J2024-0026  
PSC2024-0002  
Revision #2  
Received 11/4/2024

**Site Plan Review**

# CAMBRIDGE KNOLL

## 165 & 185 E. AVON ROAD

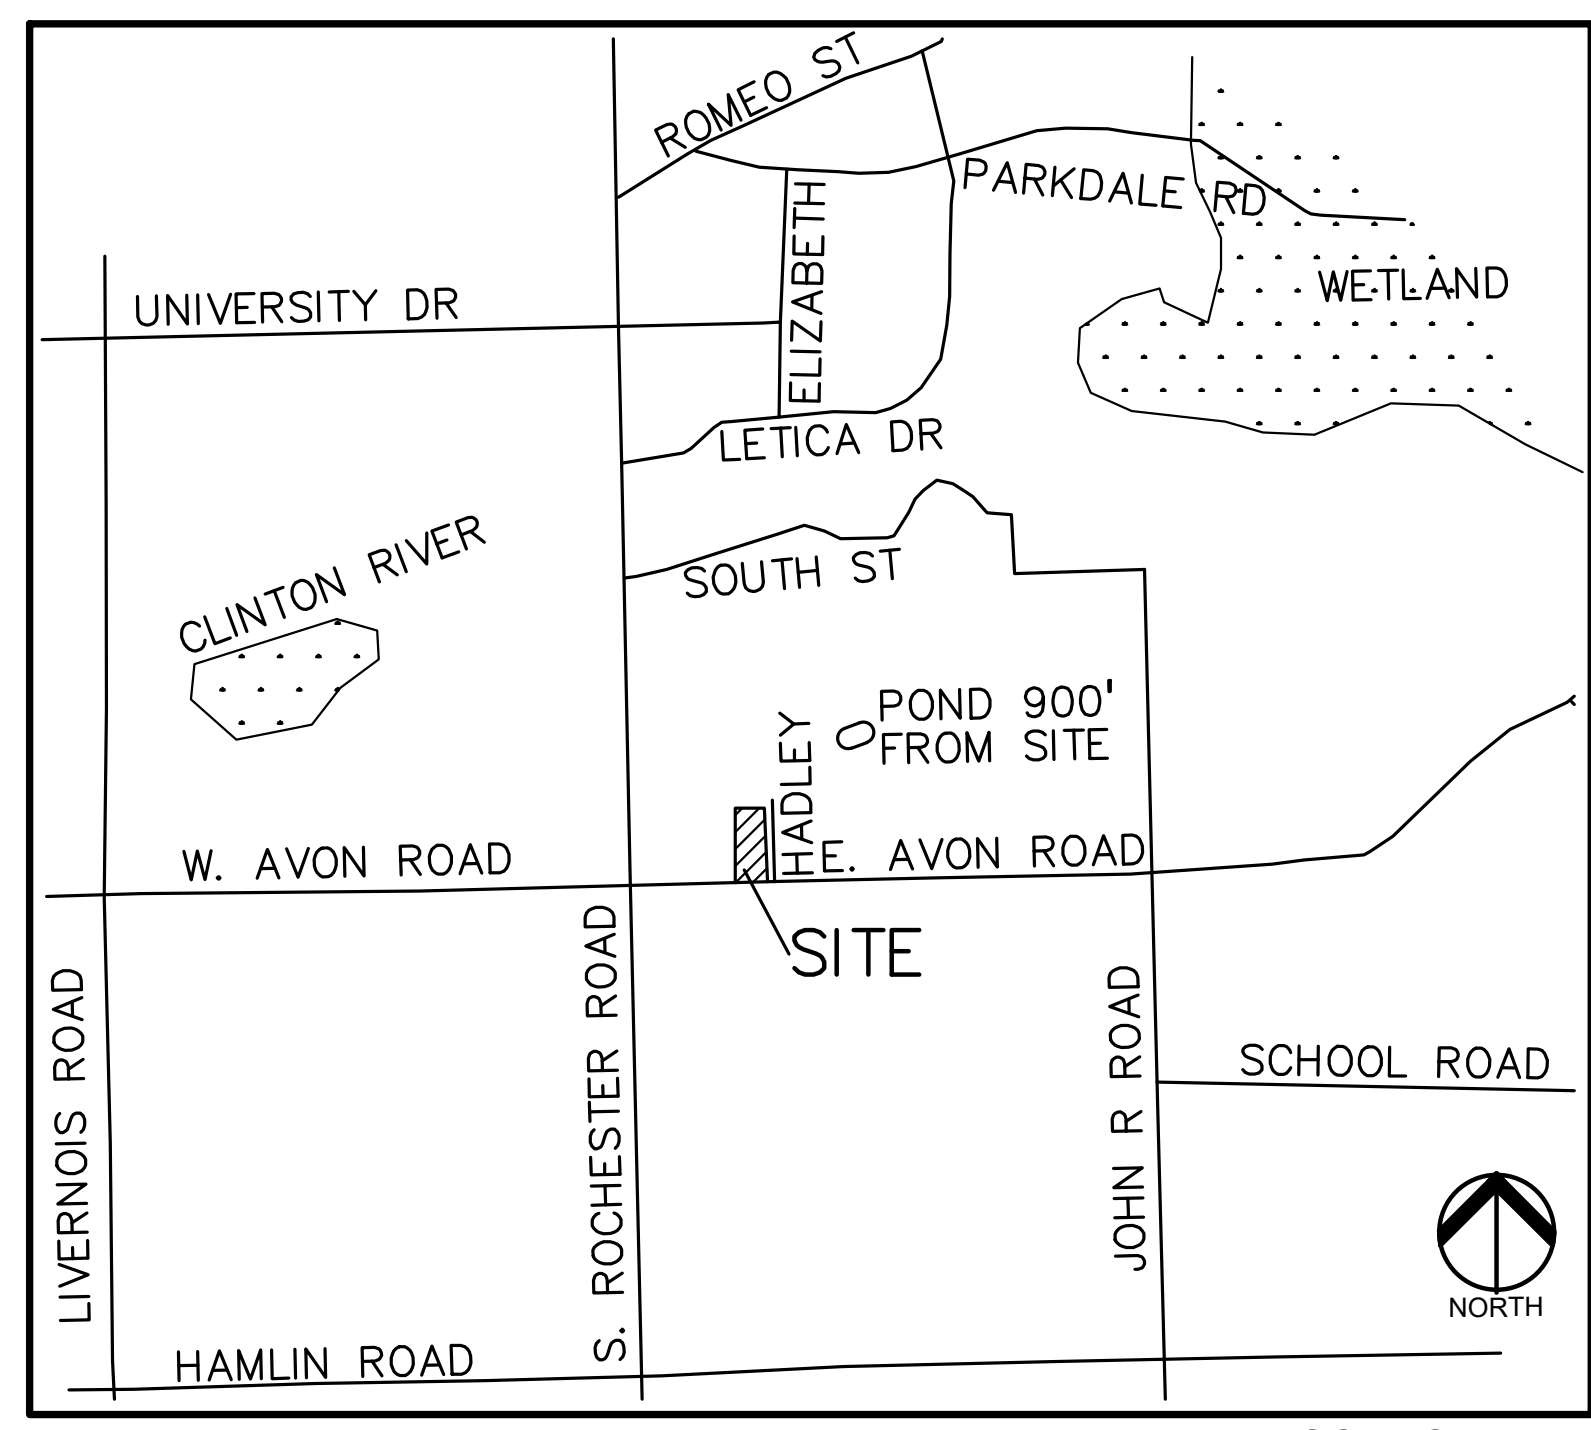
Provide RCOC permit

## LANDSCAPE PLANTING DETAILS & NOTES

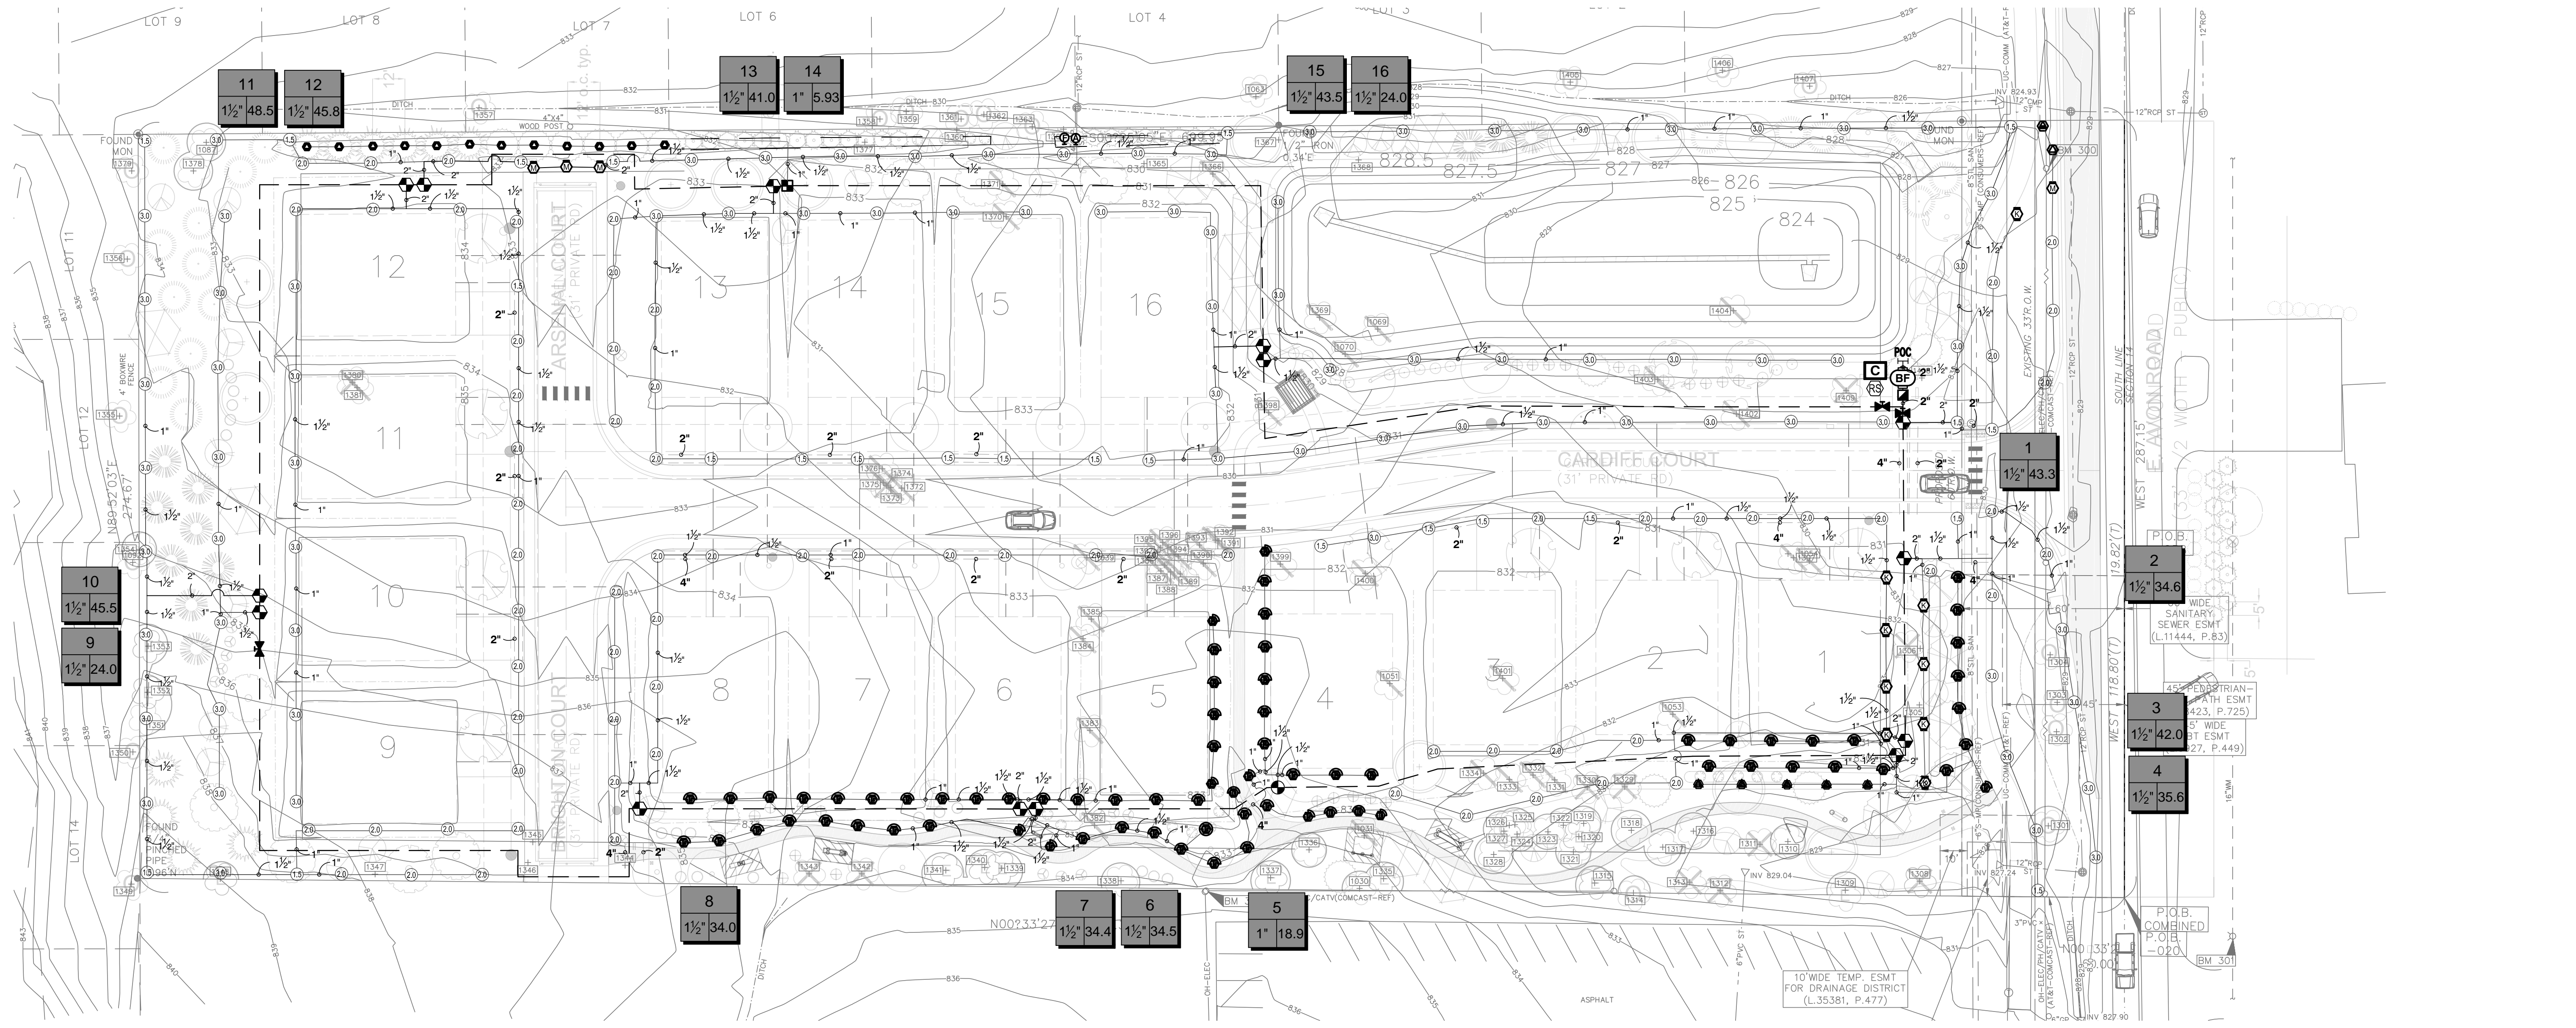
ensure planting does not interfere with fire hydrant
